# **Technical Notice**

Issue Date: March 17, 2021

Implementation Date:	
Product Name:	March 17, 2021	
DRPC-120-BT Series	Implementation Type:	
	Implement on next production

This notice is to inform you of changes to the DRPC-120-BT series

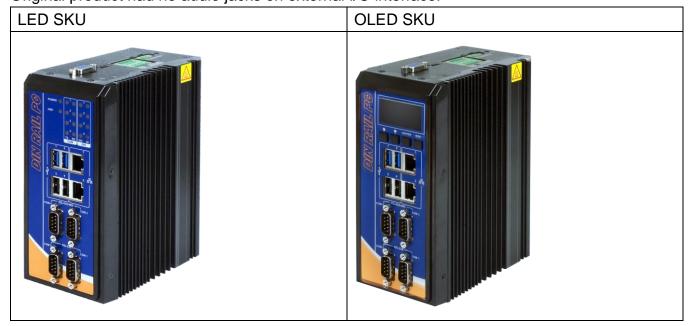
Realtek announced the End of Life (EOL) of ALC662 Series 5.1 Channel High Definition Audio Codec IC due to the shortage of wafer and promptly FAB capacity issue.

Removing DRPC-120-BT series audio function. Removing Audio Codec IC ALC662-GR and other related electronic components and connectors by BOM change.
